ADDENDUM

UH-1N

# CATEGORY II AIRFRAME AND SUBSYSTEMS EVALUATION

TECHNICAL REPORT No. 71-37

**Figure 1 BL-8300 Hoist Installed in Forward Right Station**

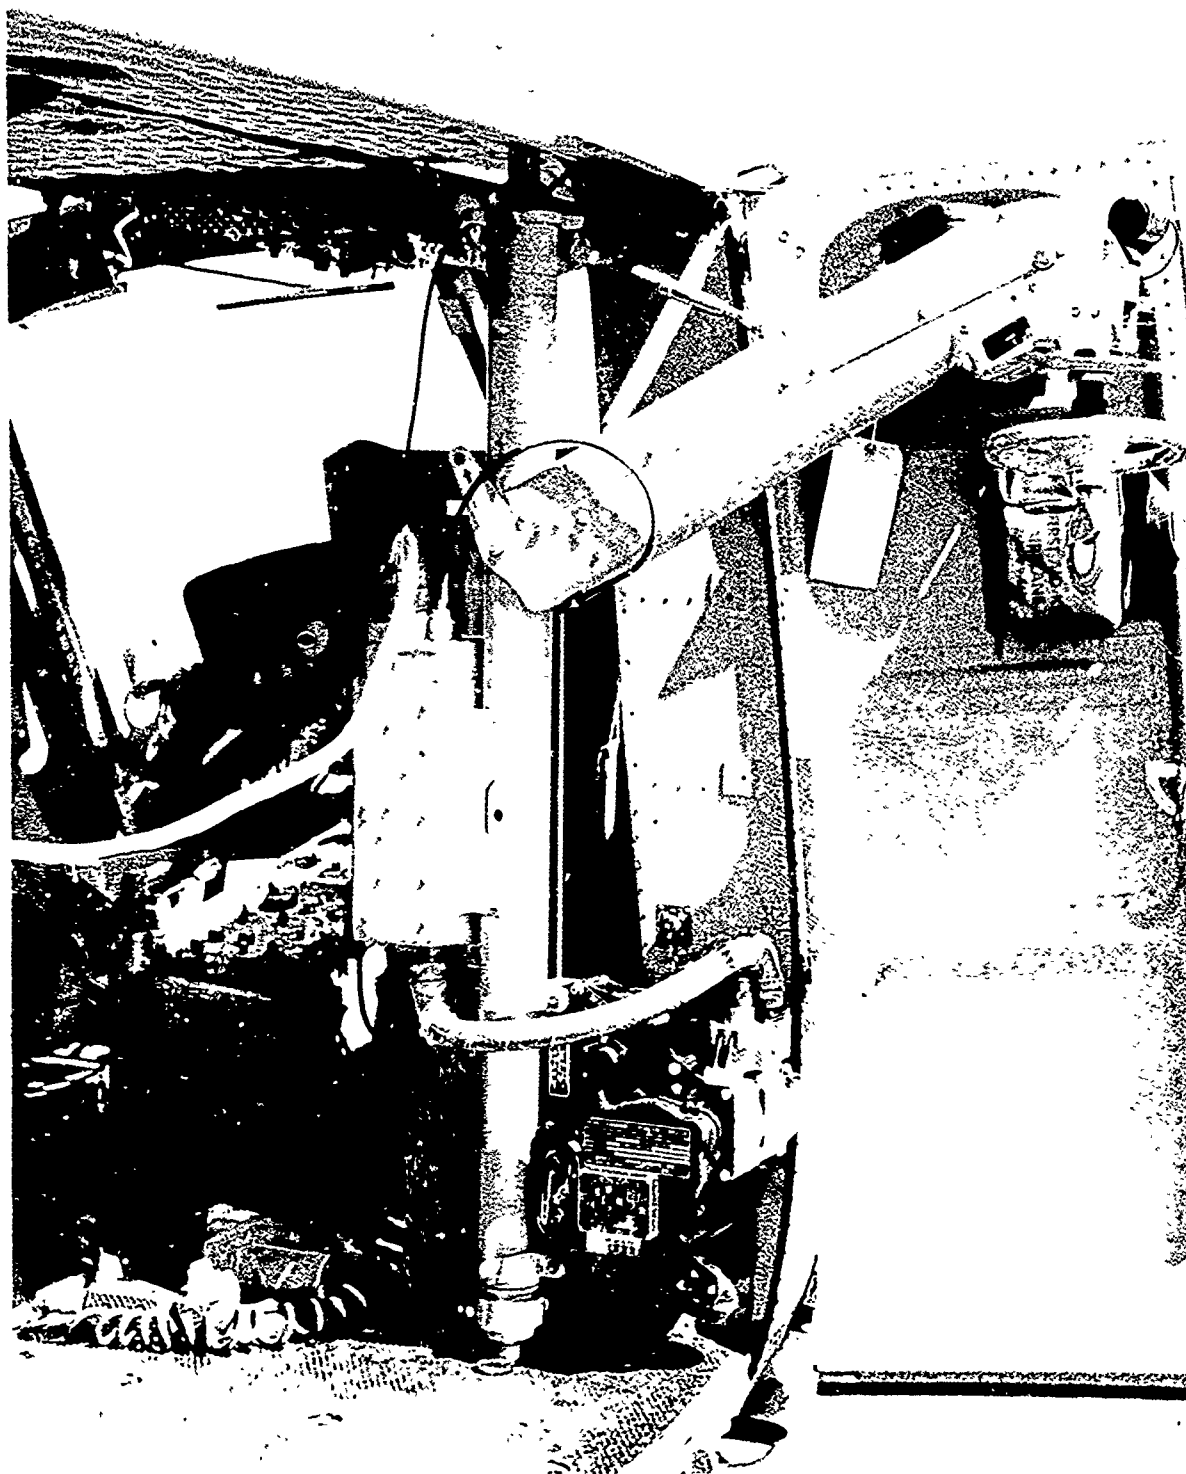
The hoist system was installed in the aircraft in the forward right station of the cargo compartment (figure 1). Ground power was applied to the aircraft. All control functions were exercised, including cable retraction and extension, and hoist boom translation. All control actions were adequate.

8. Concur with intent. ASD has procured an ECP to provide positive closure lock of the rescue hoist hook using a "pip pin".
9. Concur with intent, but not with recommended action. ASD will change procedures to pre-position the non-essential bus switch to MANUAL before using the hoist. Modification is not warranted, so long as electrical power is assured.

Figure 21 IFF Antenna Patterns

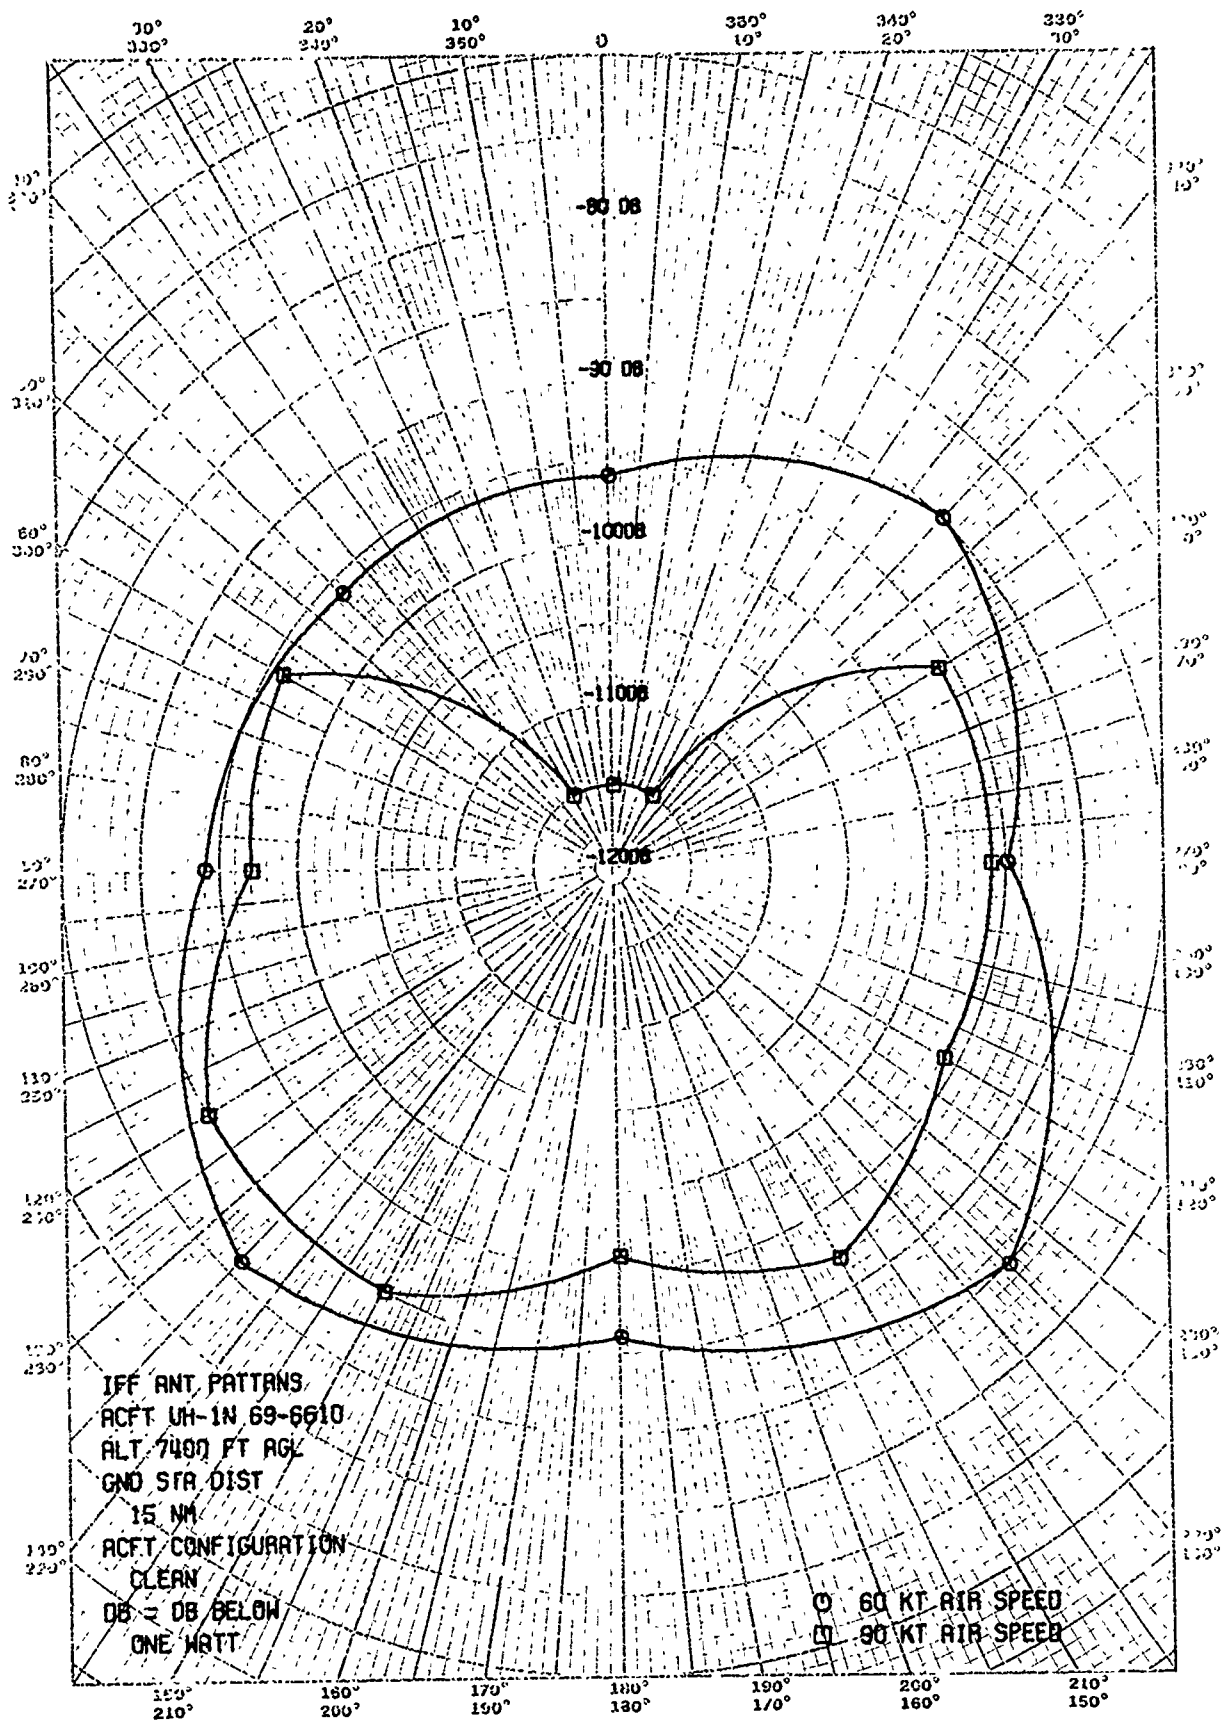
The radiation pattern of the AT-741A Antenna was measured by flying cloverleaf patterns over a point 15 NM from the PACF, at 10,000 feet pressure altitude. Radar tracking was used to vector the aircraft over the reference point on each heading. The relative signal strength was measured while interrogating the transponder in mode 2. The UH-1N aircraft used one IFF antenna located on the bottom of the aircraft near the rear of the fuselage. The antenna radiation pattern obtained at 90 KIAS (figure 21) was unacceptable due to the deep null off the nose of the aircraft. This null was not observed at 60 KIAS, when the nose-down attitude of the aircraft decreased approximately 4 degrees. An additional top-mounted fuselage antenna with an antenna switching unit should be installed to improve the radiation pattern. (R 31)

31. Concur. ASD will request an ECP to correct this deficiency. An additional IFF antenna and SA-1474/A switching unit may be required.

**Figure 38 External Aircraft Noise Levels, Low Hover**

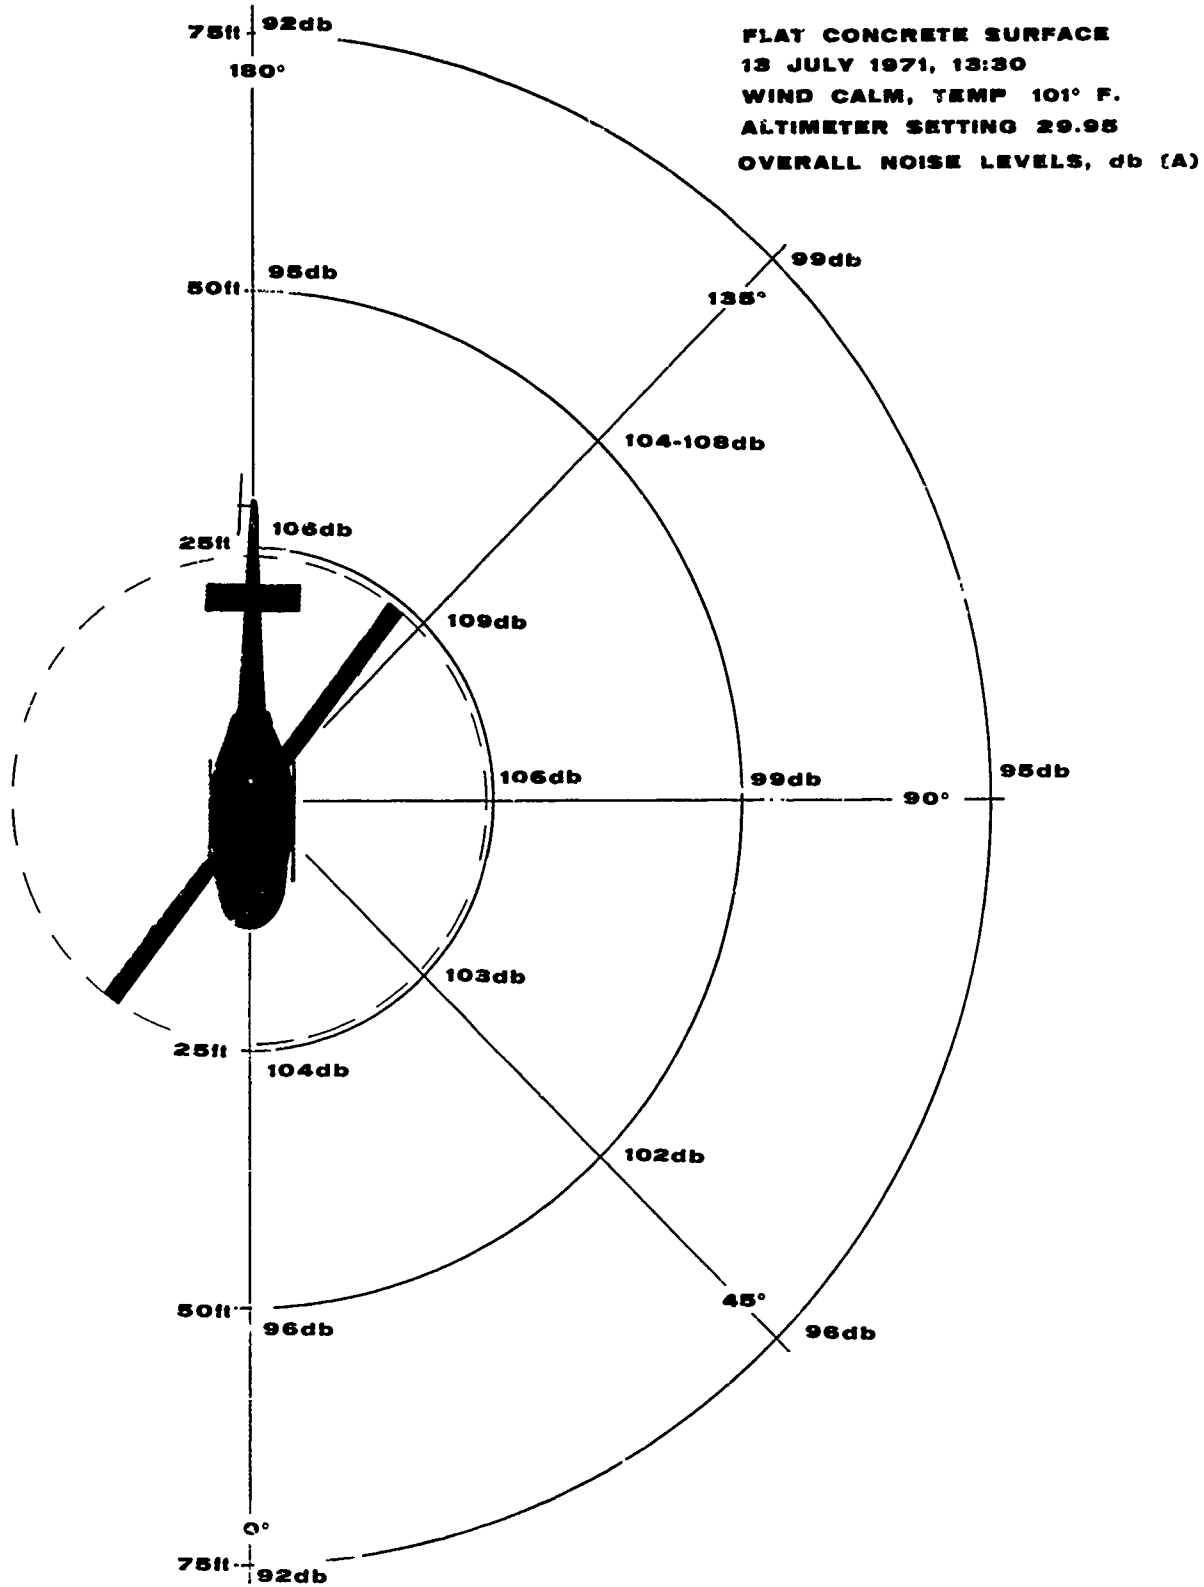
Figure 38 illustrates overall noise levels in the area surrounding the aircraft during low level hover operations. The measurements were made with a General Radio Model 1551C overall noise level meter using the A-weighted scale. The results reflect the sound environment to which ground personnel are exposed during approach, departure, and hover conditions such as hoist operations.

grenade launcher noises. For grenade launcher operations exposure should be limited to mission essential personnel, and those who are exposed should employ the best available hearing protection. Modifications to the grenade launcher should be made, if possible, to reduce the noise levels at the source. (R 55, R 56)

56. Concur with intent, but not with recommended action. Noise reduction modifications to the grenade launcher are not feasible within the original scope of the UH-1N acquisition program. This recommendation should be considered in future procurements, if applicable.
